Analysis of Combustion Turbine CO₂ Emission Rates
Under the 2024 Greenhouse Gas (GHG) New Source Performance Standards (NSPS)
for Fossil-Fired EGUs

Prepared for:

American Public Power Association
Midwest Ozone Group
Power Generators Air Coalition

August 4, 2025

Figure 2-1. Calculated CO₂ Emission Rate: Simple Cycle

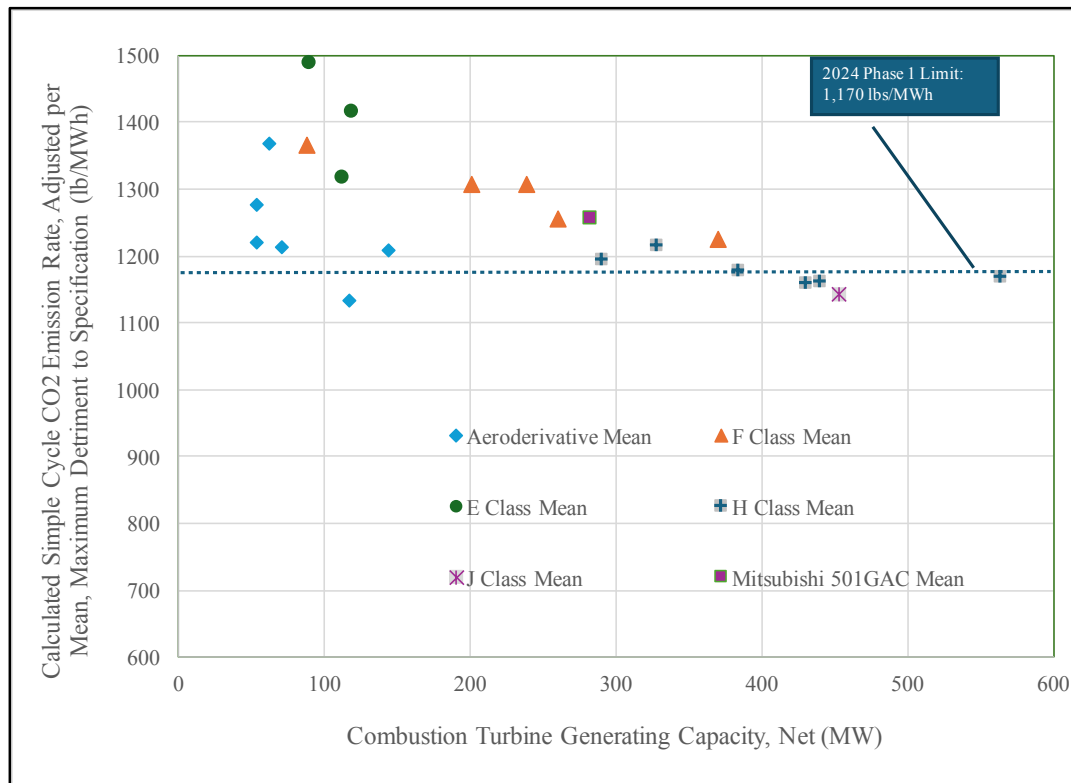
Figure 2-1 reflects the calculated CO₂ emission rate for the various combustion turbine designs designated in Appendix Table A-1. The mean value as determined from Table 2-1 is presented for each turbine classification, with data from each turbine class represented by the same marker and color. Figure 2-1 shows that based on the suppliers' specification and Gas Turbine World adjustments, a limited number of large H-Class, J-Class, and aeroderivative CTs, with the mean adjustment values are theoretically expected to have lower CO₂ rates than the current Phase 1 CO₂ emission standard of 1,170 lbs/MWh. However, no simple cycle CT with maximum adjustment (data not plotted for simplicity) can, even theoretically, meet the limit. A notable number of designs – in particular E-Class and F-Class models, and most aeroderivative designs – have specification CO₂ emissions rates adjusted by the mean value equal to or exceeding the 2024 Phase 1 CO₂ standard of 1,170 lb/MWh.

As a result, it appears that the 2024 Phase 1 CO₂ emission standard of 1,170 has the effect of prohibiting the use of a significant number of CT designs – several aeroderivative; all E-Class

and F-Class, and most H-Class – as simple-cycle CTs operating at intermediate load. These types of units are, effectively, relegated to low-load duty under the current rules.

- Simple Cycle. Figure 2-1 shows only one aeroderivative and several H- and J-Class units, using the calculated CO₂ emission rates based on the mean adjustment to specified heat rate, can meet the Phase 1 limit of 1,170 lbs/MWh; notably with little or no compliance margin. The use of the mean adjustment is corroborated by real-world data.

Figure 2-2. Calculated CO₂ Emission Rate: Combined Cycle

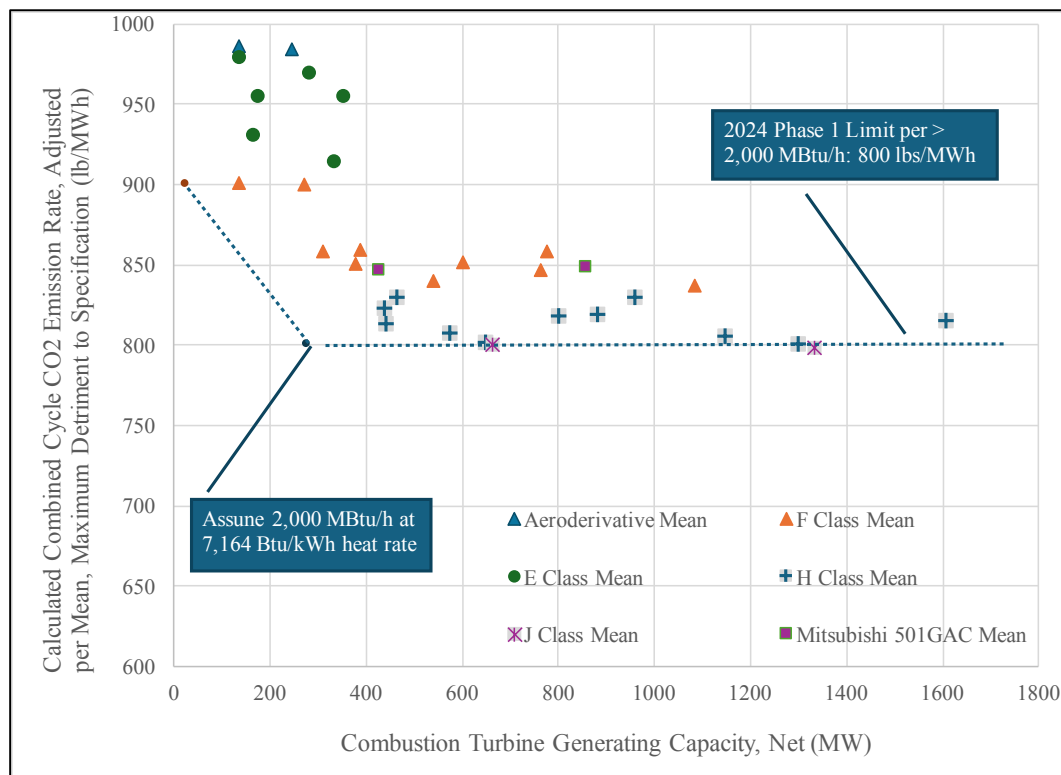
The Figure 2-2 combined cycle CO₂ emission rates reveal a pattern like that for simple cycle CTs – some of the largest H-Class and J-Class units can theoretically emit at less than the CO₂ emission standard of 800 lbs/MWh for the mean adjustment to heat rate. Those CTs would have a very small compliance margin. All other CT designs would likely exceed the standard, even at mean adjustment. The calculated CO₂ emission rates using the maximum adjustment (data not plotted for simplicity) of all currently available CTs would exceed 800 lb/MWh. None of the E-Class or aeroderivative design combined cycle units can meet the 2024 Phase 1 standard for base load units (which increases to 900 lb/MWh for units with heat input less than 2,000 MMBtu/h), for either the mean or the maximum.

- Combined Cycle. Figure 2-2 shows a limited number of F-, H-, and J-Class units can meet the CO₂ standard based of 800 lb/MWh, with little or no margin, based on suppliers' heat rate at ISO conditions and adjusted for mean detriments. The use of the mean adjustment is corroborated by real-world data.

of operating F-Class and larger CT-based combined cycle units. This is evident from examining Figure 2-2, which presents the calculated CO₂ emission rate based on the suppliers' specification, and a "mean" adjustment of 12.5%. The CO₂ emissions in this figure for a 602-MW F-class combined cycle in 2 x 1 configuration is shown as 850 lbs/MWh. It should be noted that the value of 24% adjustment is implied by Figure 2-4 for the F-Class based population, approximating not the "mean" adjustment but the maximum. Also, Figure 2-4 shows a relatively high standard deviation of 171 lbs/MWh, implying approximately 6 units can emit at 751 lbs/MWh or less. This means the Dresden data resides in the lowest statistical cohort of F-Class combined cycle data.

Figure 3-3. CO₂ Emissions Rate vs. Nameplate Capacity: 30 Simple Cycle Units Operating Between 20 and 40% Capacity Factor

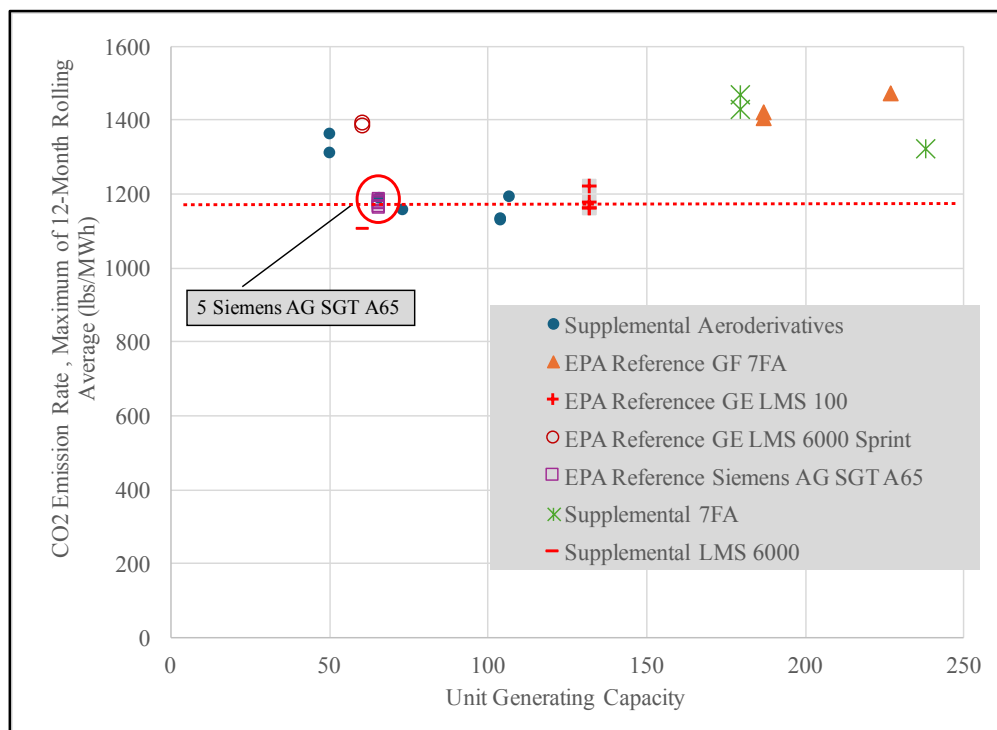
The Figure 3-3 legend identifies data designated by EPA as references for the 2024 Phase 1 standard for simple cycle units operating at intermediate load. The legend also identifies the supplementary units introduced by this study. Notably, all of the units that can meet the intermediate load CO₂ performance standard are aeroderivative. Six of the 16 units cited by EPA are found to operate at or below the Phase 1 rate of 1,170 lbs/MWh (although 3 exceed by only 2 to 8 lbs/MWh). Three of the 14 supplemental units introduced by this study emit at less than the standard.

Figure 4-1. Combustion Turbines Suppliers' Specification of Gross Heat Rate: Aeroderivative and Frame Design of 50-300 MW

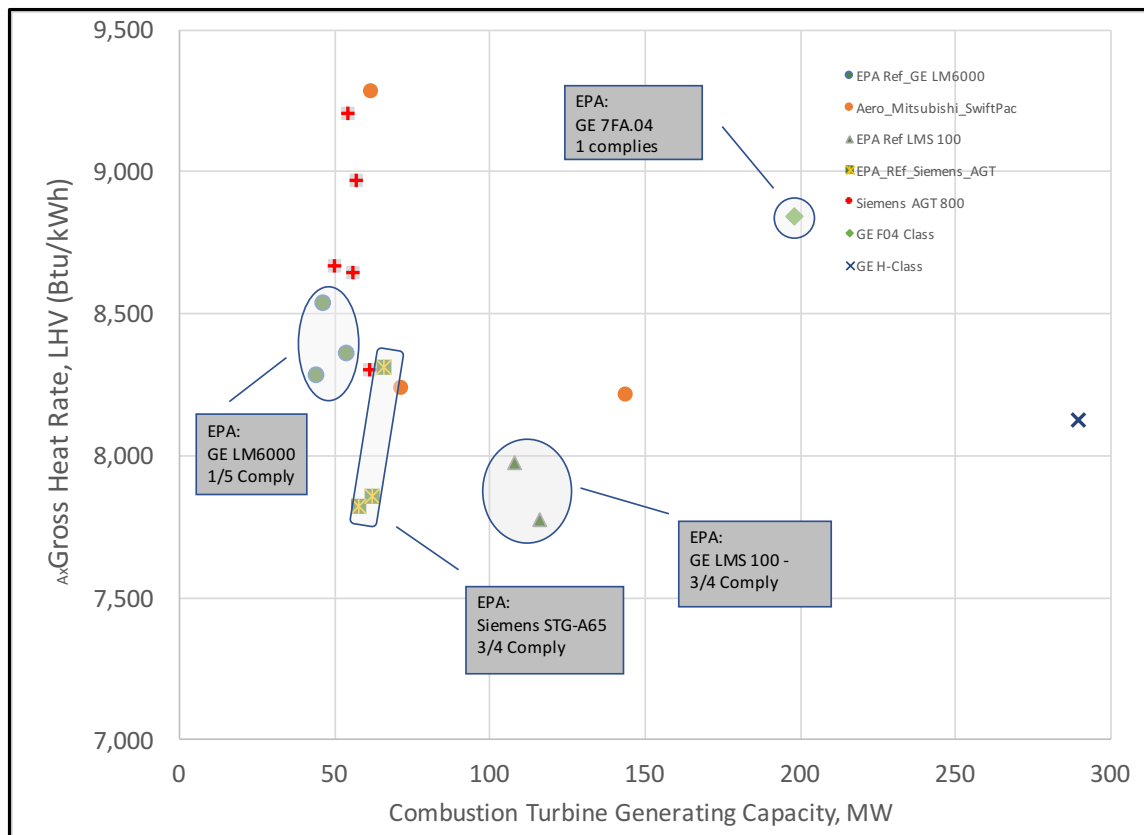
Second, EPA's reliance on only three specific aeroderivative models is even more problematic. Figure 4-1 presents the theoretical heat rate specified by the supplier (i.e., full-load, ISO conditions) for a sample of aeroderivative and intermediate capacity frame turbines broadly available in the U.S. Figure 4-1 calls out the three aeroderivative turbine designs designated by EPA as the basis of the 1,170 lb/MWh standard for intermediate-load simple-cycle turbines.

Putting aside the fact that half of the referenced model units did not meet the standard selected by EPA, any other CT model with an inherent (i.e., specification) heat rate exceeding that of the three aeroderivative models that EPA selected as the basis of the performance standard likely cannot meet the standard (at least not under operating duty and conditions similar to those experienced by the reference units). This includes many other aeroderivative models, as well as all E-Class and F-Class frame CTs, and all but the largest H-Class and J-Class frame CTs. All of these models are, effectively, limited to operating at low load (i.e., less than 20% capacity factor) because they cannot meet the intermediate load performance standard.

- EPA selected the two turbines with the lowest specified heat rate - the Siemens SGT-A65 and GE LMS100 to set the simple cycle CT CO₂ standard for units in the intermediate load subcategory. A third turbine – the GE LM6000 – presents similarly low specified heat rate in comparison to the remainder of the aeroderivative population. Almost without exception, the heat rates of all other aeroderivative-class turbines are higher. Establishing a 1,170 lb/MWh CO₂ emission rate standard effectively prohibits the use of aeroderivative-class turbine on the market for intermediate load duty, except for the three models favored by EPA.

- Many frame design turbines of 180-300 MW of generating capacity – representing likely candidates for simple-cycle applications in the U.S. – exhibit higher heat rates (and thus CO₂ emission rates). These turbines are desirable options for utilities due to their size, operating costs, and other operational factors. Several utilities have placed current orders for these units for several years out. EPA by setting the standard at 1,170 lb/MWh is effectively prohibiting the construction of most frame-design turbines with a capacity of 180-300 MW for intermediate load duty.

Figure 4-2. Combustion Turbine Inlet Pressure Ratio, Thermal Efficiency: Aeroderivative, Frame Designs

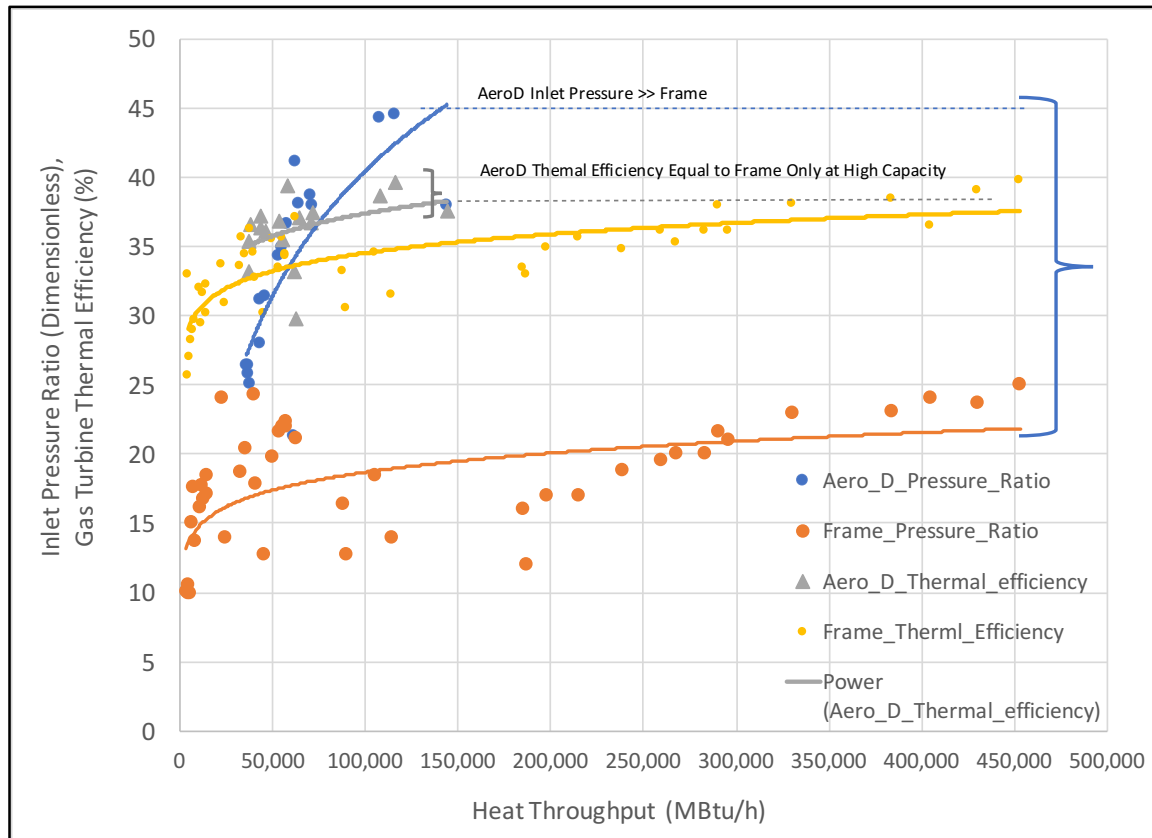
Figure 4-2 compares the turbine inlet pressure ratio for aeroderivative and frame design turbines as a function of heat throughput. In the context of this discussion, the turbine inlet pressure ratio is the ratio of the air pressure delivered to the turbine combustor, relative to ambient air. This critical ratio for aeroderivative turbines (blue data and trend line) approaches 45, while for frame turbines this metric is limited to 25 (orange data and trend line).

Figure 4-2 also shows the suppliers specified (inherent) thermal efficiency for each category of turbines. The figure shows that aeroderivative designs (gray data and trend line) enjoy higher thermal efficiency than frame designs (yellow data and trend line). Figure 4-2 also shows that the turbine inlet pressure ratio for frame turbines is well below that of aeroderivative – in many cases by half. As a result, the specified thermal efficiency of frame turbines in this category is less than aeroderivative by 2-4 percentage points. H- and J-Class units exhibit thermal efficiency approaching 40% – but only for these largest capacity turbines.

In summary, EPA's methodology of basing simple cycle CO₂ emission rates on aeroderivative turbines is flawed, as it allows the high inlet turbine pressure ratio achievable only on these smaller generating capacity units to drive the theoretical thermal efficiency of the CT and,

Figure 4-3. Example of Data Evaluation, Correlation Used for Dresden Plant Evaluation

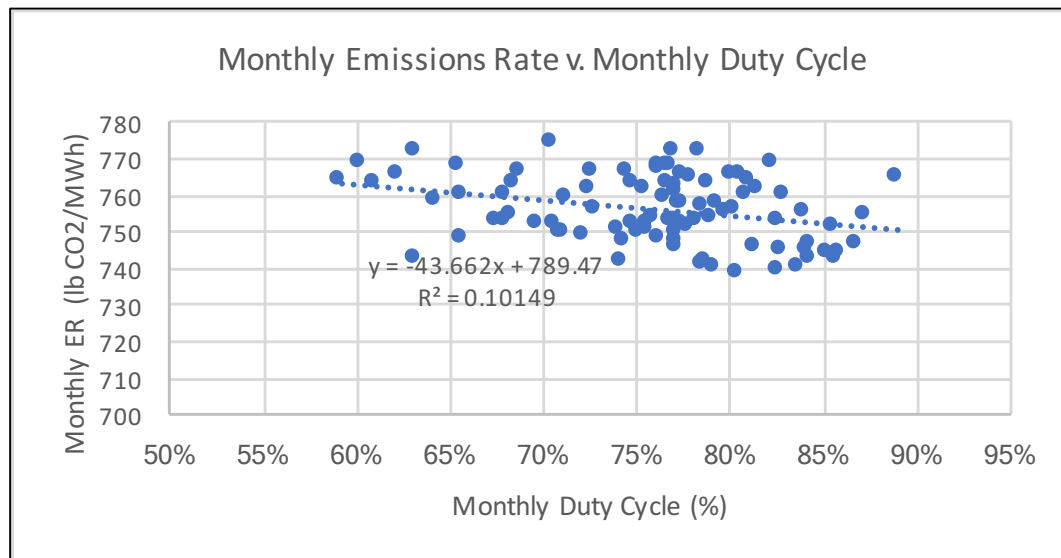
Using the 59 units, EPA developed a database reflecting the conventional 1x1 arrangement and dry cooling tower by “adjusting” CO₂ emission from units with multi-shaft arrangement (increasing CO₂ by 1%) and wet cooling (increasing CO₂ by 1.4%).³⁹ EPA also recognized that operation at low load elevates CO₂ emission rate. Consequently, EPA used historical data from each unit describing CO₂ emission rate as a function of load to project any increase in emission at 40% capacity. Figure 4-3 presents data from the Dresden Plant used for this purpose.⁴⁰

There is no analysis in the 2024 rulemaking of whether the Dresden CO₂ emission performance is representative of what combined cycle units generally can achieve. First, Dresden is an F-Class based combined-cycle unit. It is not representative of smaller, E-Class and aeroderivative-based combined cycle units. In addition, the Dresden CO₂ data is not representative of the bulk

Figure 4-4. CO₂ Emissions from the Combined Cycle Population: Role of Dresden

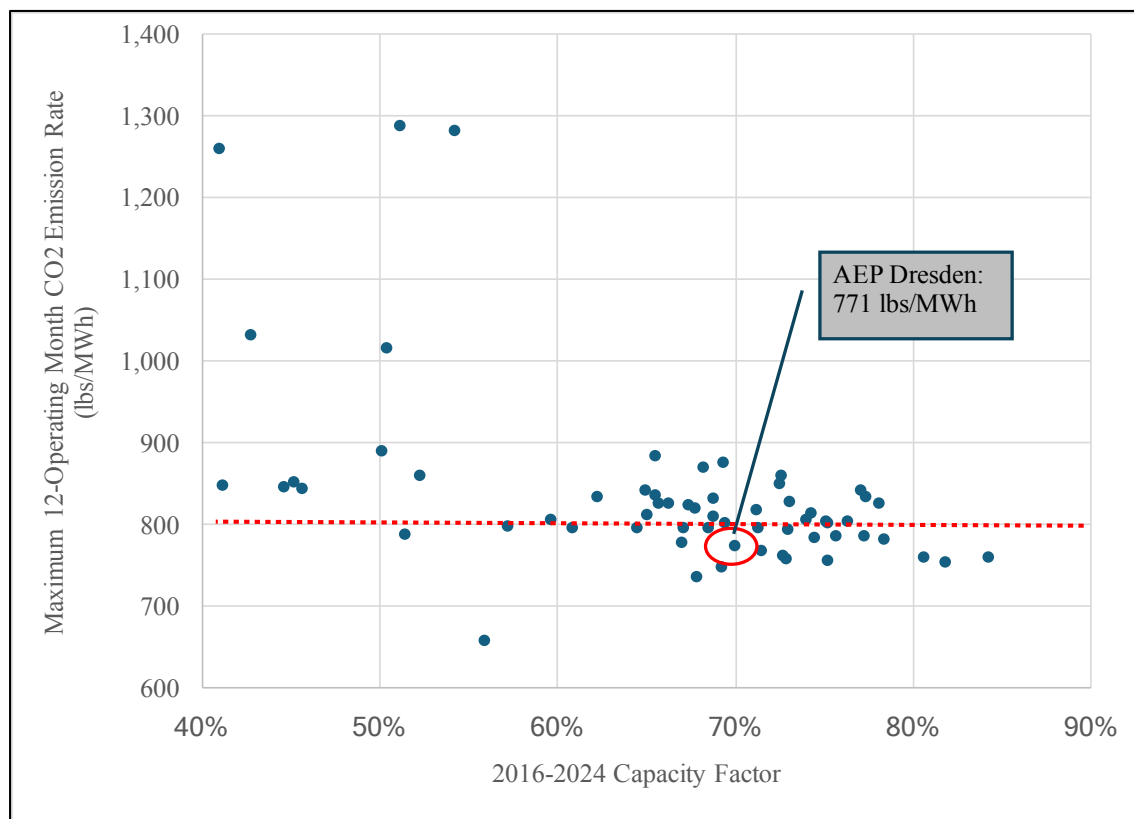
Figure 4-4 depicts the data previously presented in Figure 3-4, but plotted as a function of capacity factor. The Dresden CO₂ emission rate of 771 lbs/MWh is called out on the figure for an annual capacity factor that averages 70% for the relevant operating years. As Figure 4-4 shows, there are approximately 10 units in the combined cycle population that emit CO₂ at a rate lower than Dresden; the vast majority of units in the database emit at higher rates. The increment provided by elevating the rate to 800 lbs/MWh does not significantly improve the margin for compliance for these units.

EPA does not offer an analysis into the 2024 record as to why they determined any new combined-cycle unit ought to be able to achieve the CO₂ emission rate achieved by Dresden. As this study emphasizes, the 12-month rolling average efficiency (and, therefore, CO₂ emissions rate) of a combustion turbine is affected not just by the inherent efficiency of the unit, but also by

operating conditions (i.e., elevation; average ambient temperature; unavoidable degradation; air inlet fouling; and condenser conditions) as well as operating duty (not just average capacity factor, but more importantly average duty factor; frequency of startup and shutdown; frequency and rate of load changes; etc.). Operating conditions are outside the control of the operator entirely. Operating duty is theoretically subject to operator control, though it is largely dictated by grid demand and constraints. EPA selected Dresden as representative, without analysis of whether Dresden itself would be able to meet the CO₂ emission rate EPA selected were Dresden located at a higher altitude, or operated at higher ambient temperature, or at a different duty (within the base load category). Nor did EPA analyze why the majority of operating combined cycle units in the database emitted CO₂ at a higher rate than Dresden. Without these analyses, there is no basis for concluding that any new unit should be able to meet the CO₂ rate that Dresden achieved under its own operating conditions and duty.

Figure 5-1. LCOE Equivalent per Adjusted EIA Analysis

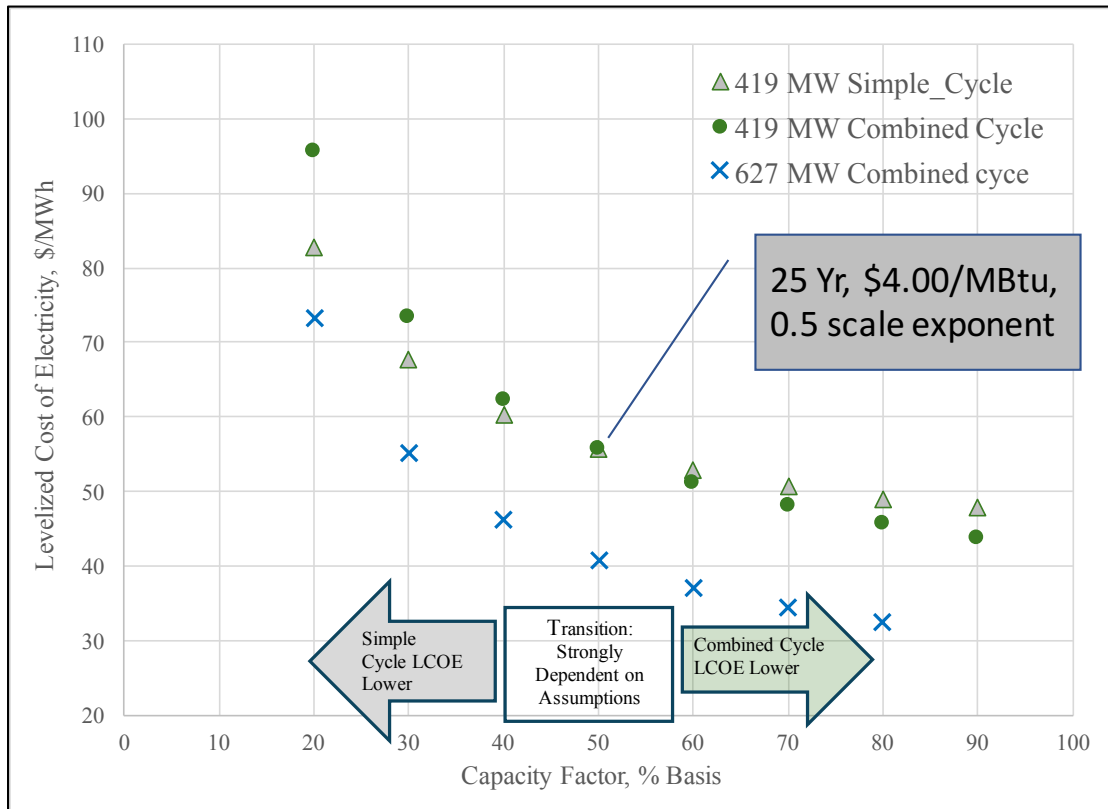
Figure 5-1 presents results of calculations reporting the LCOE (as \$/MWh) from the EIA study. Three options are addressed: the 419 MW simple cycle (Case 4), the 627 MW combined cycle (Case 6), and an extrapolated “new” combined cycle unit of 419 MW combined cycle (extrapolated Case 6). The LCOE is presented as a function of capacity factor. Figure 5-1 results are presented for generating capacity, combined cycle capital cost, and natural gas price that differ very slightly from those employed by EPA. Specifically, these are slightly shorter lifetime (25 years), higher capital cost (resulting from the use of a 0.5 scaling factor), and a natural gas price (\$4.00/MBtu). These represent small changes from EPA’s input and are at least equally representative of future conditions.

Figure 5-1 shows that, using these factors, the LCOE from a simple cycle remains lower than that of a combined cycle up to a capacity factor of 52%.⁵⁴ The LCOE from the 627 MW (Case 6) combined cycle unit is significantly lower for the same 25-year lifetime and \$4.00/MBtu natural gas costs, enabled by strong economies of scale.
